CZECH SPORT AIRCRAFT	<h1>SERVICE BULLETIN</h1>	Czech Sport Aircraft a.s. Na Záhonech 212, 686 04 Kunovice Czech Republic office@czechsportaircraft.com	
		No.: SB-CR-042	Rev.: -
		Date: 2018-05-14	Date: -
Page: 1 of 14

MODEL AFFECTED:	PS-28 Cruiser and SportCruiser / PiperSport aircraft under EASA regulation
SUBJECT:	Landing Light Replacement (original TrailTech 4213-SX for TrailTech D112-SX)
AIRCRAFT AFFECTED:	All aircraft according to section "MODEL AFFECTED", as applicable
COMPLIANCE:	Apply this Service Bulletin when replacement of the original Trail Tech 4213-SX landing light is needed

This Service Bulletin contains instructions for replacement of the original landing light Trail Tech 4213-SX (hereinafter also referred to as the "Original landing light") by the new Trail Tech D112-SX landing light (hereinafter also referred to as the "New landing light"). The action also requires replacement of circuit breaker / switch circuit breaker with current rating of 3A.

Figure 1 – Dismounting of the Original landing light Trail Tech 4213-SX

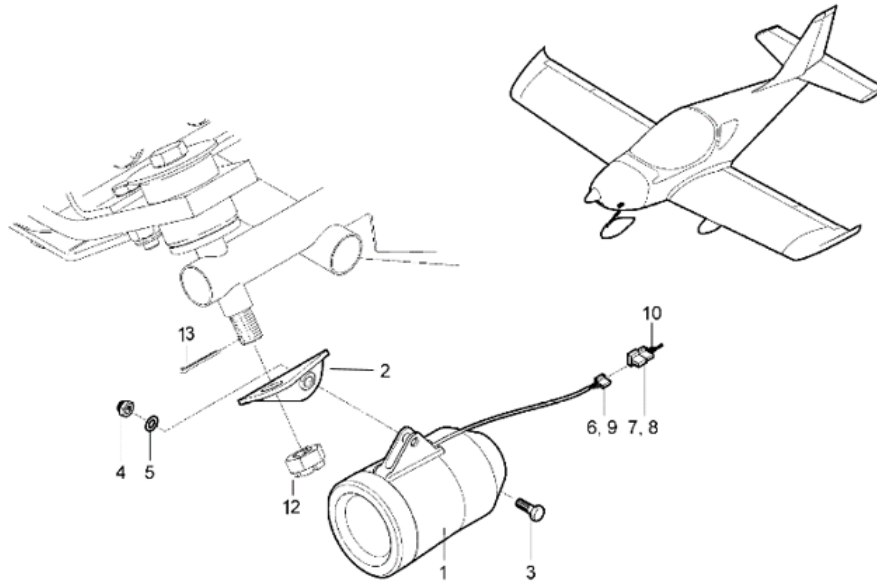
- 1.7 Disconnect the Original landing light from the aircraft wiring system - cable with the connector (6, 9) from the wiring (7, 8, 10), see Figure 1 above.

- 1.8 Remove the Original landing light (1) with bracket (2) from the engine mount.
- 1.9 Screw back the castle nut (12) and secure with the new cotter pin (13). To eliminate the slackness use the washer (33).

Figure 2 - Mounting of the New landing light Trail Tech D112-SX

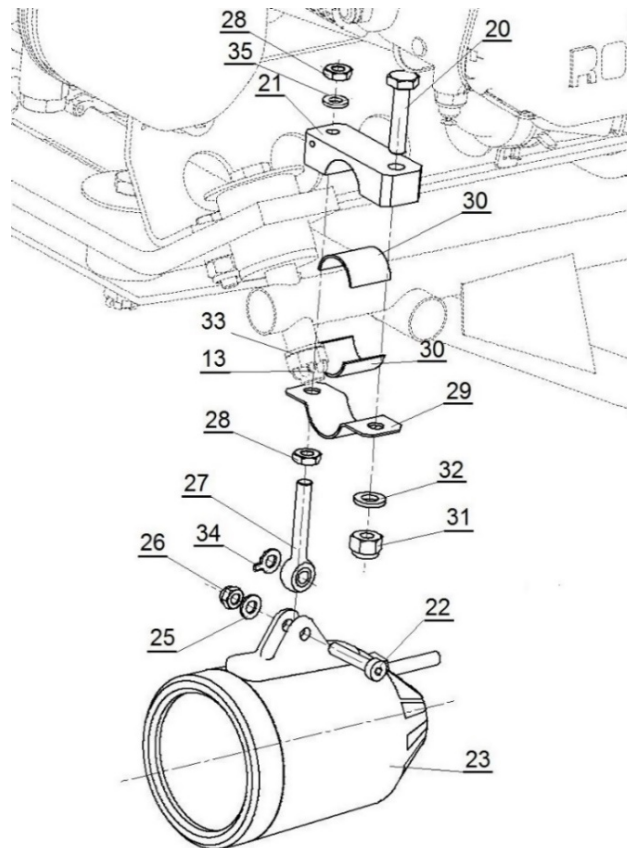
- 1.10 Install the New landing light (23) with the new holder (21, 29, 30) supplied by the Czech Sport Aircraft using connecting parts (20, 31, 32, 22, 25, 26, 27, 28, 35), see Figure 2.

- 1.11 If the gap between the light mounting (23) and the threaded eye (27) on the screw (22) is 0,5 mm or more, insert the washer (34) between the light mounting and the threaded eye. Tighten the screw (22) firmly.
- 1.12 Interconnect the airplane connector (8) with the landing light connector (24), see Figure 1 and Figure 3 above.
- 1.13 Install the engine lower cowling and check the landing light position – it must be adjusted so that the optical axis of the landing light passes through the middle of the engine lower cowling opening, see Figure 3 and Figure 4. Use the parts (21, 29, 30) for adjustment.

Figure 3 – The New landing light position adjustment

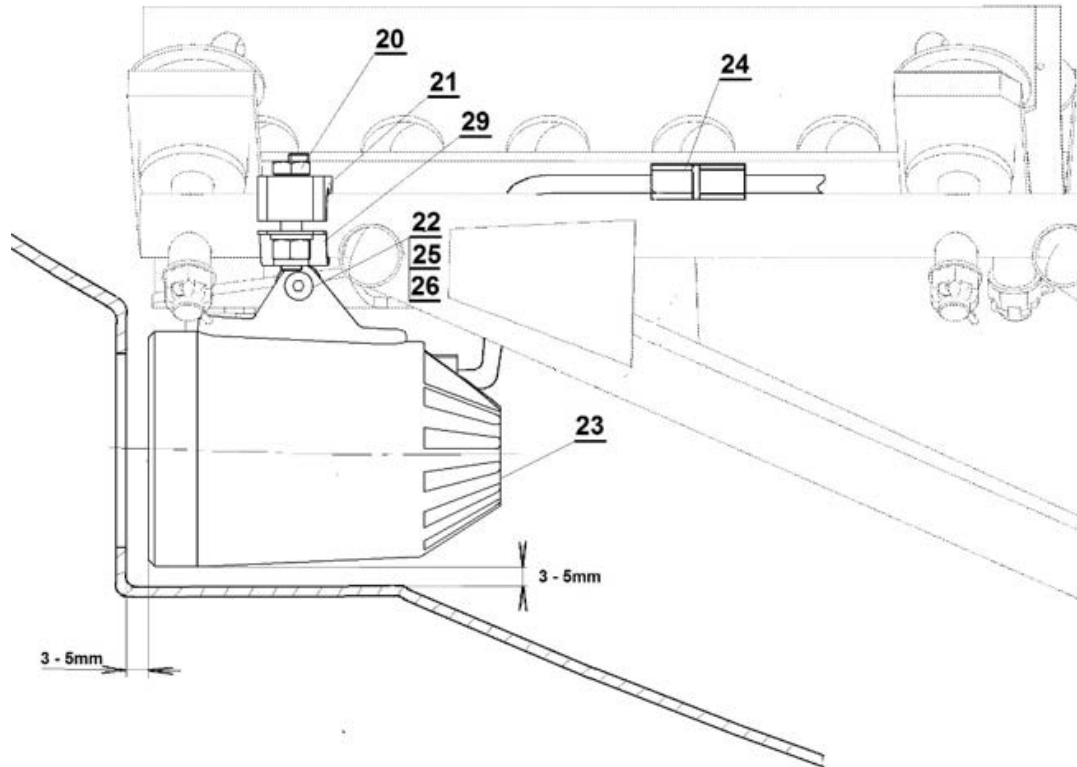
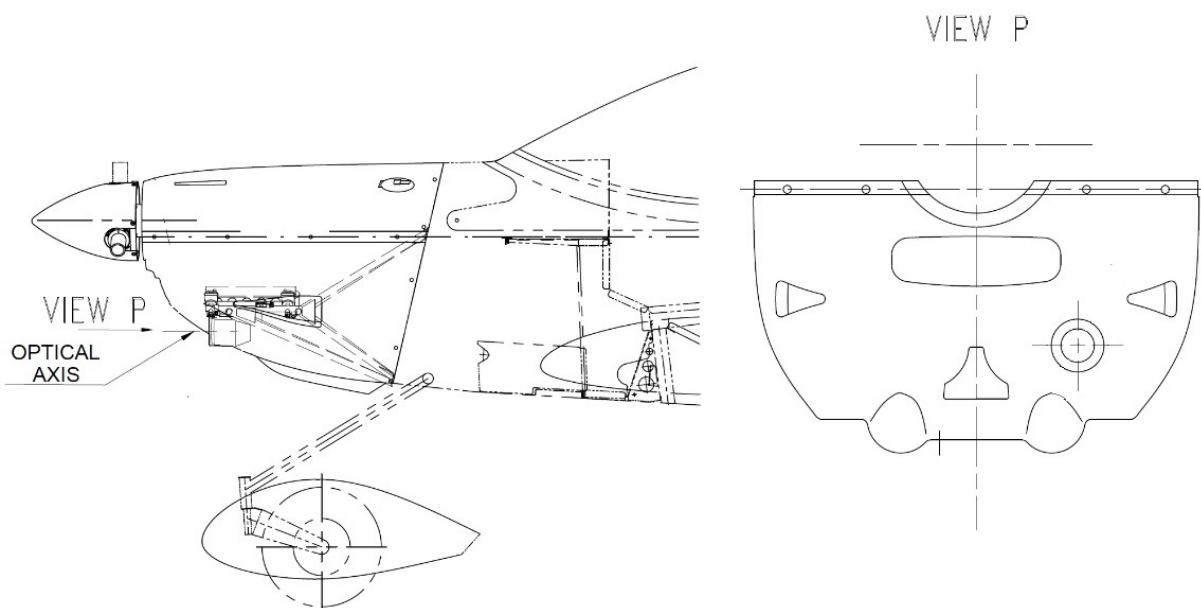
Note: To reach the adjustment parts (21, 29, 30), the engine lower cowling has to be removed first. To check the adjustment, the engine lower cowling has to be installed first.

- 1.14 Once a correct landing light position is set, remove the engine lower cowling and secure the adjustment by tightening the nut (28) and connecting parts (20, 31, 32).
- 1.15 Find the circuit / switch circuit breaker of the landing light (LDG L) on the instrument panel (see the CR-MM-1-0-00, latest revision) and check the rating. The range of 3A is correct current rating for the New landing light circuit / switch circuit breaker rating.

Figure 5 - The LDG L MS3320-x circuit breaker. Placed on the right instrument panel

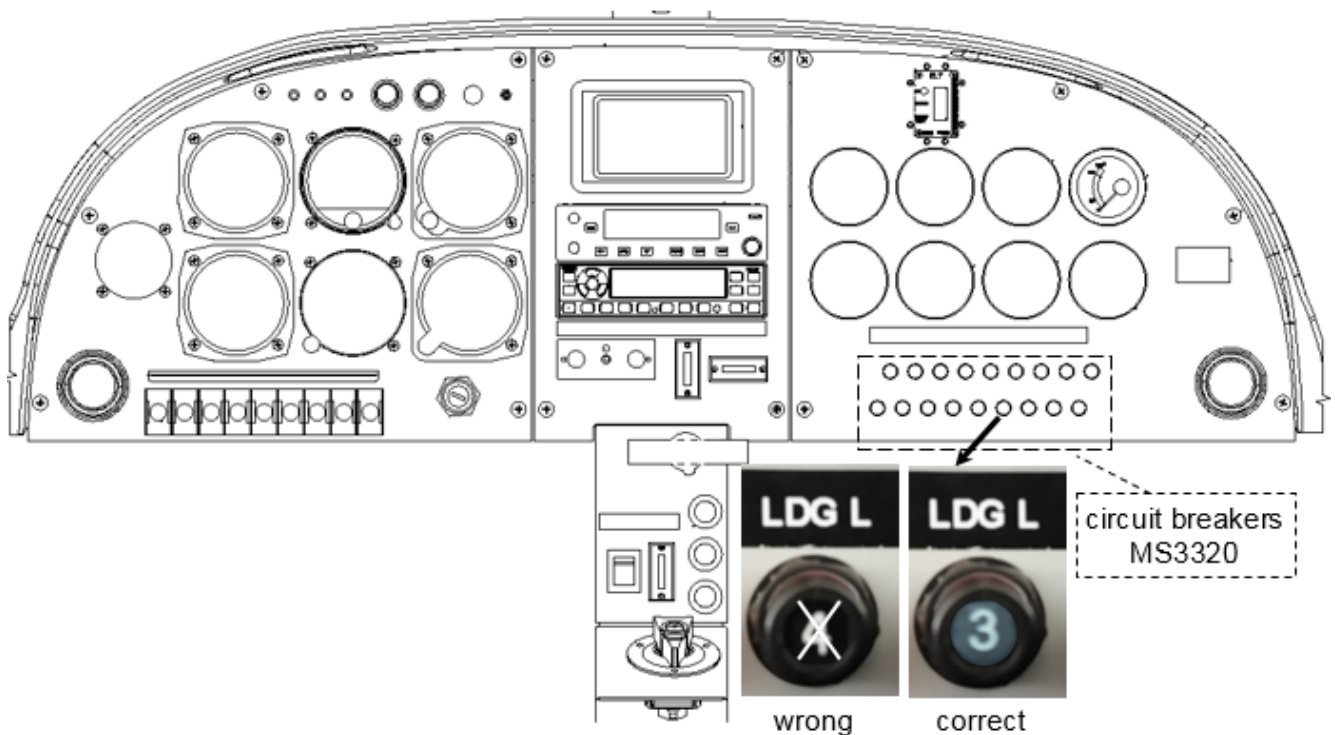
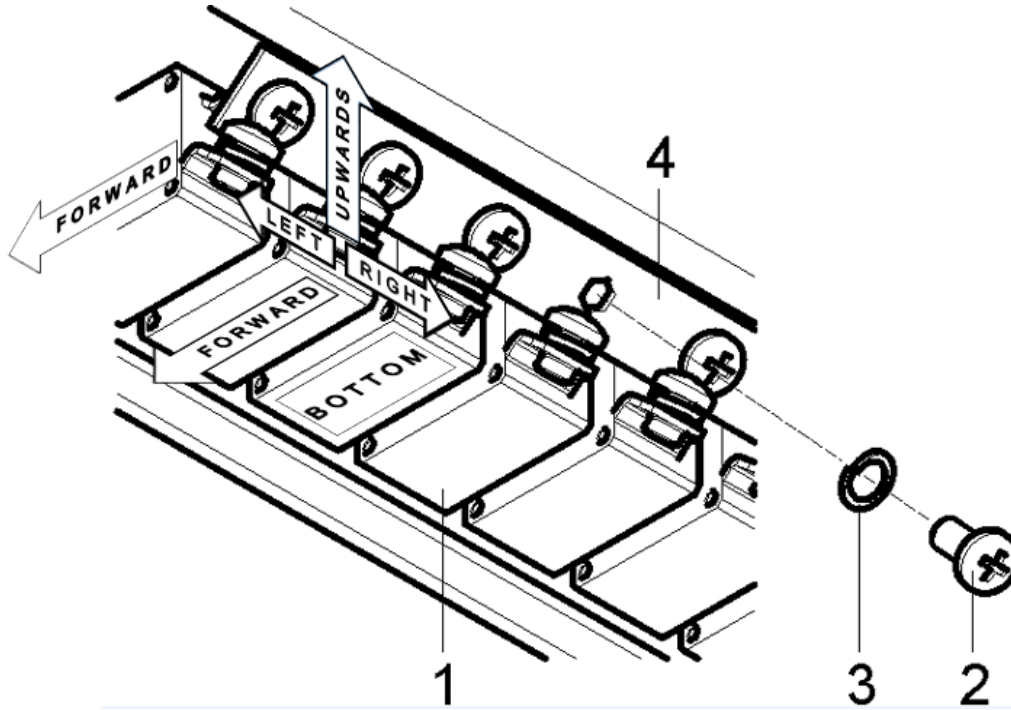
The MS3320 LDG L circuit breaker is installed on the right instrument panel, see Figure 5, The circuit breaker is marked "LDG L". Replacement of the circuit breaker has no effect on mass and CG of the airplane.

- 2.1 Determine the LDG L circuit breaker (text "LDG L") on the right instrument panel, see Figure 5.
- 2.2 Secure that the MASTER BATT switch is turned off and disconnect the battery terminals, see the CR-MM-1-0-00, point 11.3.2, latest revision.
- 2.3 Remove the screws (2) with the washers (3) from the main supply bus (4) of all the circuit breakers, see Figure 6.
- 2.4 Remove the main supply bus (4) from the all circuit breakers (1) on the right instrument panel, see Figure 6.

Figure 7 - MS3320-x circuit breaker removal / installation

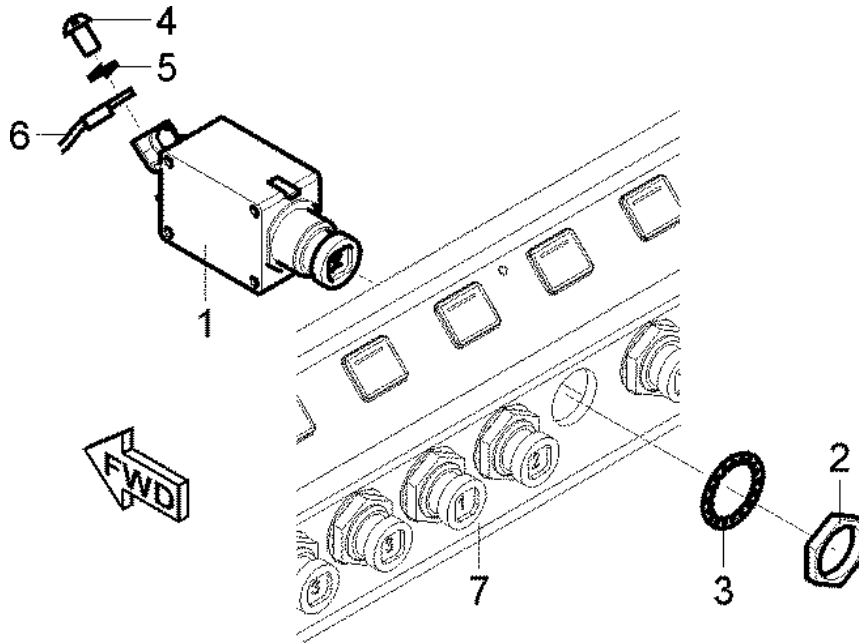
- 2.5 Release the screw (4) with the washer (5) and disconnect the cable (6) from the LDG L circuit breaker, see Figure 7.
- 2.6 Unscrew the nut (2), the washer (3) and remove the original LDG L circuit breaker (1), see Figure 7. To unscrew the nut (2) use the ½ inch wrench.

- 2.7 Use the new LDG L circuit breaker from the replacement package (MS3320-3, current range of 3A), see Figure 5. Insert the circuit breaker in the right instrument panel and fix using the nut (2) with the washer (3), see Figure 7.

- 2.8 Connect the cable (6) using the screw (4) with the washer (5), see Figure 7.
- 2.9 Fix the main supply bus (4) back to the all circuit breakers using the screws (2) with the washers (3), see Figure 6.

Figure 8 - The LDG L V31X2M1G-x switch circuit breaker. Placed on the left instrument panel

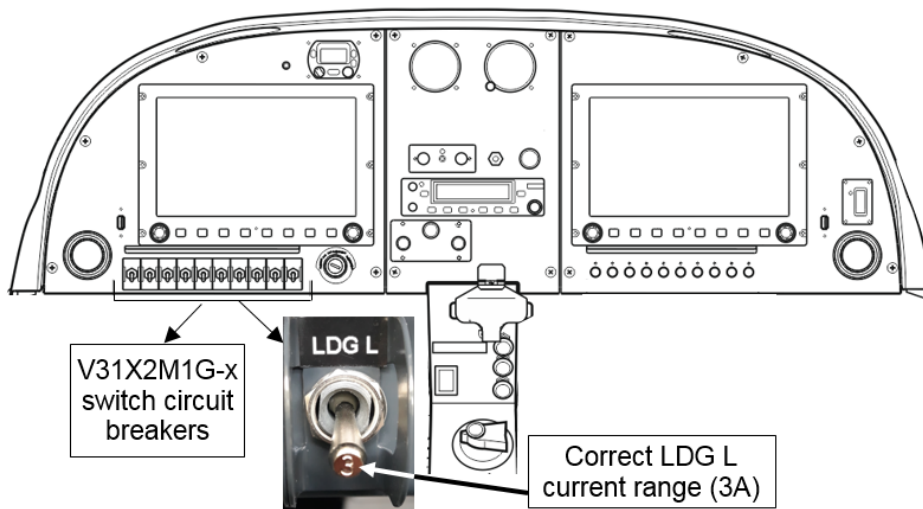
The V31X2M1G-x switch circuit breaker (marked "LDG L") is placed on the left instrument panel. Replacement of the switch circuit breaker has no effect on mass and CG of the airplane.

- 3.1 Determine the LDG L switch circuit breaker (text "LDG L") on the left instrument panel, see Figure 8.
- 3.2 Secure that the MASTER BATT switch is turned off and disconnect the battery terminals, see the CR-MM-1-0-00, point 11.3.2, latest revision.
- 3.3 Release the screws (2) with the washers (3) of all the switch circuit breakers and remove the main supply bus (4), see Figure 9.

Figure 9 - Connection the new LDG L V31X2M1G-3 switch circuit breaker to the main supply bus.

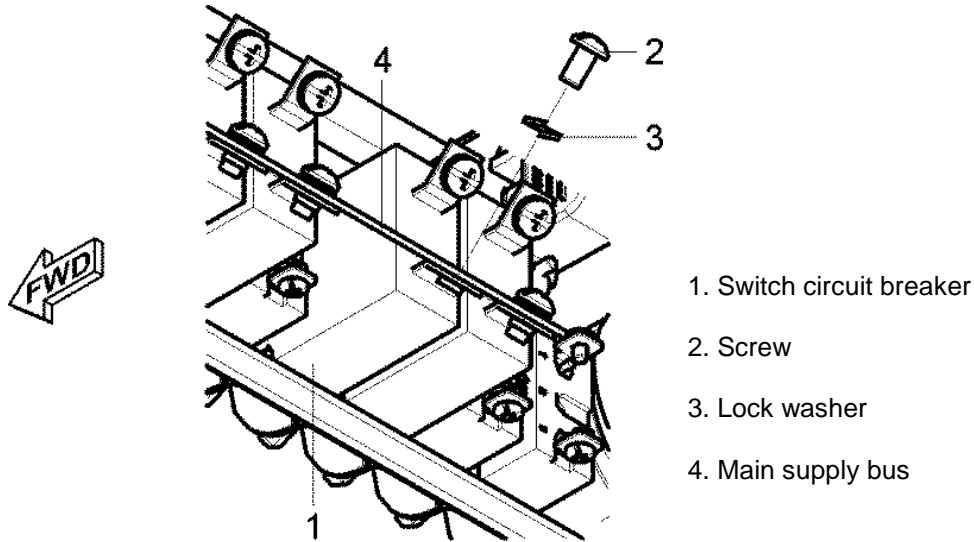
- 3.7 Use the screw (6) with the washer (7) and connect and fix the cable (8) to the new switch circuit breaker (1), see Figure 10.
- 3.8 Fix the main supply bus (4) back to the all switch circuit breakers using the screws (2) with the washers (3), see Figure 9.

Figure 10 - V31X2M1G-x switch circuit breaker removal / installation

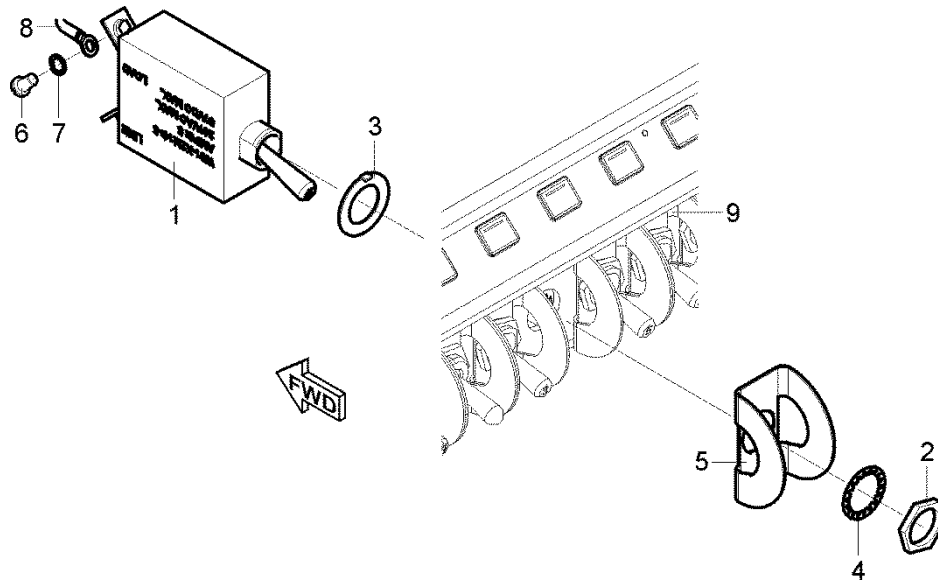
- 3.4 Remove the nut (2), the washers (3, 4) and cover (5) of the original LDG L switch circuit-breaker (1), see Figure 10.
- 3.5 Remove the screw (6) with the washer (7), and disconnect the original LDG L switch circuit-breaker cable (8), see Figure 10. Remove the original LDG L switch circuit breaker (1).

- Note:** The new V31X2M1G-3 switch circuit breaker hardware; screws (6), nut (2), washers (3; 4; 7), see Figure 10, are included in the package.
- 3.6 Use the new V31X2M1G-3 LDG L switch circuit breaker (current range of 3A) from the replacement package and insert it in the left instrument panel instead of the original switch circuit bracket. Apply the cover (5) and fix the switch circuit breaker using the nut (2) with the washers (3, 4), see Figure 10.
